## RM REP001 Penshurst Parish Council representation Environment Agency technical response, September 2020

Figure 1: Key locations of road flooding identified by Penshurst PC

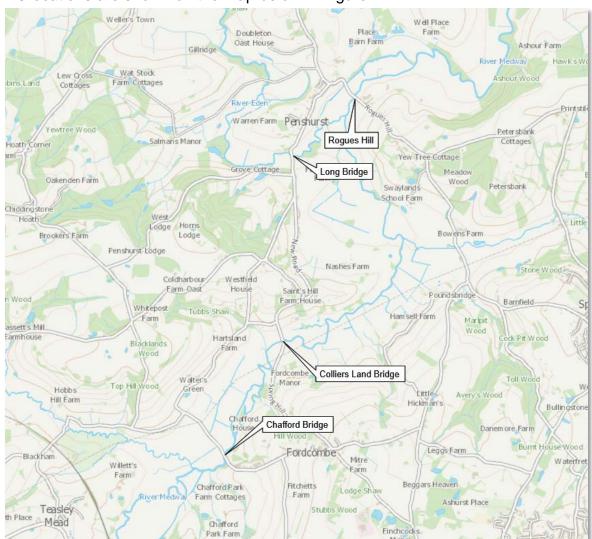
1. Key roads around Penshurst, including Chafford Bridge, Colliers Land Bridge, Rogues Hill and Long Bridge currently experience flooding. Penshurst Parish Council is concerned that future use of the Leigh Flood Storage Area (FSA) will exacerbate the situation and cause flooding of the roads on a more regular basis and for a longer period.

Roads generally flood and become impassable in the following order: 1) Chafford Bridge, 2) Colliers Land Bridge, 3) Roques Hill, 4) Long Bridge.

Figure 4: Increase in flood depth in a 1.33% flood event. 28.05m AOD vs 28.6m AOD

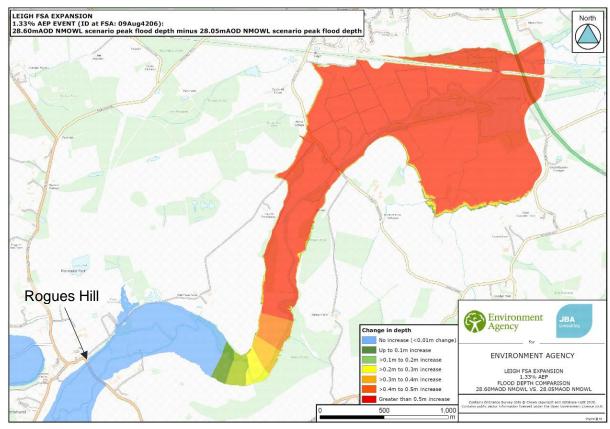
Penshurst Parish Council have expressed concern that future use of the Leigh FSA will exacerbate the flooding of the roads and cause this to occur on a more regular basis and for a longer period.

The proposed change to increase the maximum impoundment level does not change this situation. This is demonstrated in Figure 4 below. Figure 4 shows the increase in flooding depth from raising the Leigh FSA maximum impoundment level from 28.05m AOD to 28.6m AOD (measured at the main Leigh FSA embankment) during a 1.33% flood event. Every flood event is different, depending on a number of factors including soil saturation and weather patterns. Modelling simulated flood events allow us to vary how much water flows down the catchment and when. The scenario in Figure 4 was chosen to demonstrate the impact of expanding the FSA because it shows the greatest change in flood depths.

There are other examples provide in section 5.1 and Appendix B of the Flood Risk Assessment. During more extreme flood events, the increase in depth as a result of the proposed change, reduces. This is because the natural flood level, which is greater, dominates.

Whilst the existing FSA can increase water levels on Rogues Hill by up to 0.1m, Figure 4 shows that the proposed expansion will not increase the depth of flooding on Rogues Hill. As Long Bridge, Chafford Bridge and Colliers Land Bridge are further upstream, the expansion will not have any impact on the flooding on these roads either.
